ILT support in coherent PHYs

(in support of comments **418**, **419**, 546, 547, 548, 549,
550, 551, 552, 397, 400)

Adee Ran, Cisco

Figure 178B-8—Training control state diagram

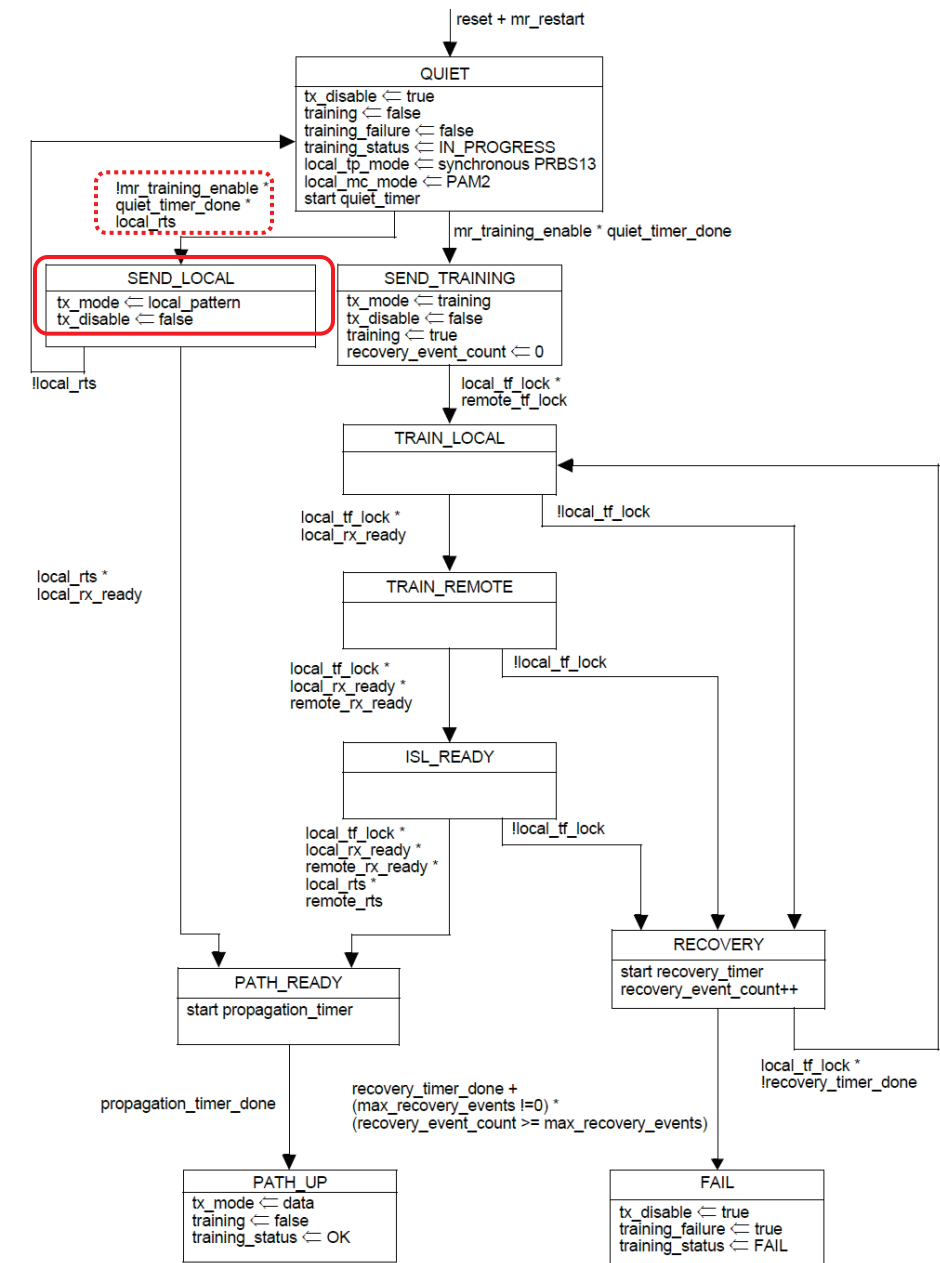
- `mr_training_enable=false` such that the left-hand part of the diagram is always used.
- While `local_rts=false`, state is QUIET
 - `tx_disable` can be implemented using the existing PMD global transmit disable function
 - Alternatively, the PMD Tx can stay on, and the client (FEC) can generate another signal, e.g. unmodulated; but currently this is not defined
- When `local_rts` becomes true, it is signaled to the peer by enabling the transmitter (SEND_LOCAL)
- When the PMD receiver is locked (`local_rx_ready`), after `propagation_timer`, the transmitter goes to DATA mode (`tx_mode=data`).
